MONTGOMERY COUNTY HISTORIC PRESERVATION COMMISSION
STAFF REPORT

Address:	402 Tulip, Takoma Park	Meeting Date:	4/24/2019
Resource:	Contributing Resource Takoma Park Historic District	Report Date:	4/17/2019
Applicant:	Tony Camilli	Public Notice:	4/10/2019
Review:	HAWP	Tax Credit:	n/a
Case Number:	37/03-19X	Staff:	Dan Bruechert

PROPOSAL: Window installation (retroactive) and site wall construction

SIGNATURE DOUBLE HUNG WINDOW (8122)
Vertical Section

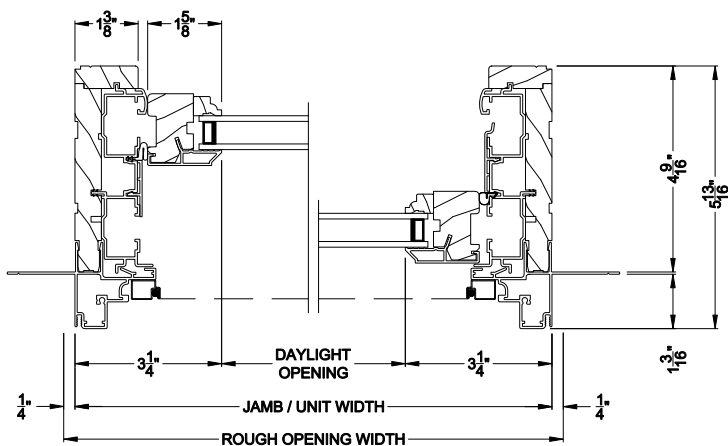
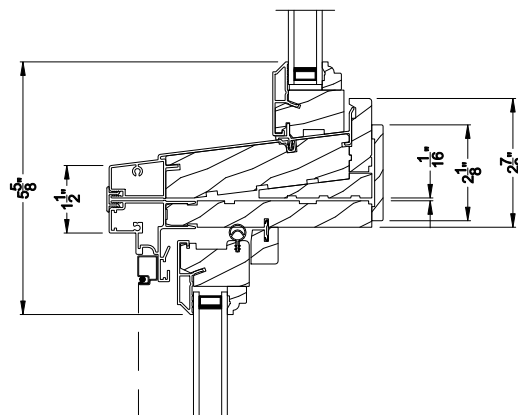
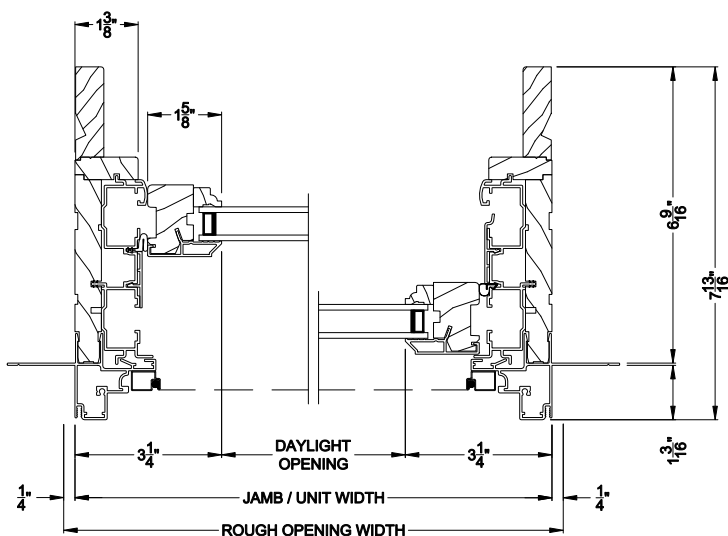
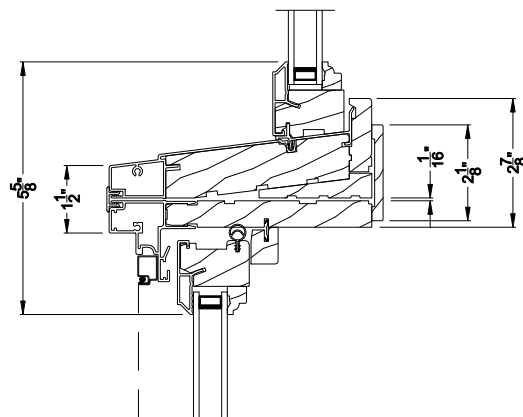
The windows that were installed are aluminum clad wood windows with vinyl jamb liners and vinyl exterior components.

At a site visit Staff determined that the jamb liners were not consistent with the approval and the applicant has revised their proposal and seeks approval for the installed window sashes and jamb liners.

The area of concern raised by Staff at the Preliminary Consultation was the use of vinyl jamb liners. The front-facing surface of the jamb liner is painted; however, the interior is exposed vinyl (this is visible in the window detail below). This feature will remain bright white and will not darken or fade over time and if and when the windows are painted, the brightness of the jamb liners will become even more apparent. The HPC has consistently approved aluminum clad windows in new construction and additions. While there were some varying opinions, Staff finds there was a general consensus that, in this instance, the vinyl jamb liners could be considered appropriate on this addition for the following reasons:

1. The addition windows are set back from the public right of way where the change in materials from the aluminum cladding to the vinyl liners is not visible.
2. Additionally, the majority of the windows will only be visible through an oblique angle (per 24A-8(b)(1)). These windows do not have as significant a visual impact as the window alteration on the historic portion of the house (per the *Design Guidelines*). For these reasons, Staff supports approval of the aluminum clad wood windows in the building addition at the subject property.

EXHIBIT 2

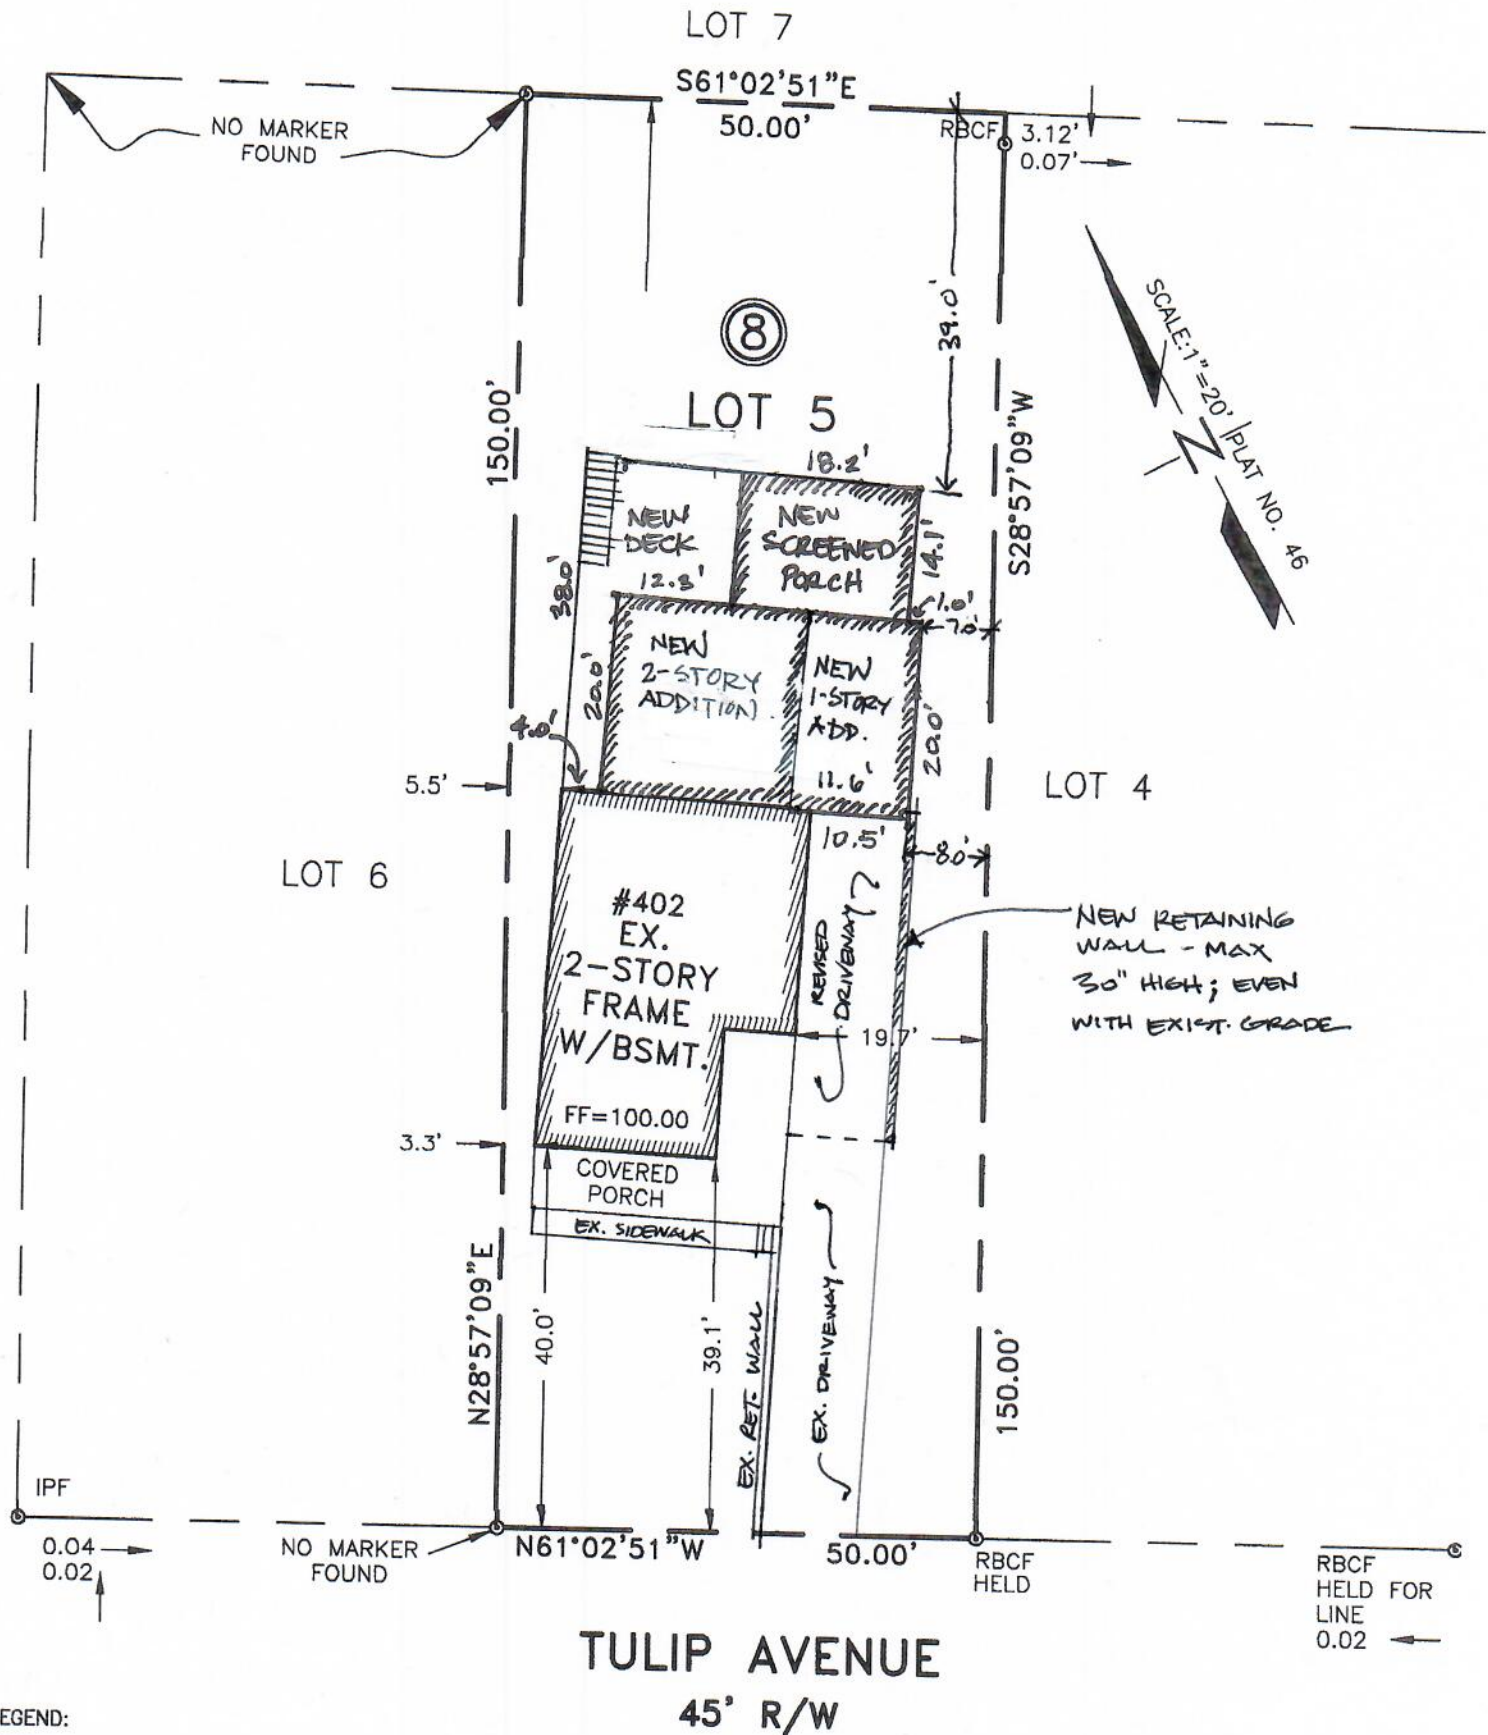
The applicant proposes construction of a retaining wall along the east (right) side of the driveway. The retaining wall run be approximately 30' (thirty feet) linear feet and will vary in height, with a maximum height of 30" (thirty inches) above grade. The wall will be constructed out of CMU block with a parged finish. The retaining wall is necessary to hold back the grade of the driveway as part of the approved new construction.

Staff finds that, though the proposed retaining wall will be in front of the lot, it will not have a significant visual impact on the streetscape because the entirety of the wall will be below the street

grade (per 24A-8(b)(1)). Staff additionally finds that the materials, parged CMU block, are appropriate for the house and surrounding district. The wall finish will match the foundation treatment of the historic house (per 24A-8(b)(2)).
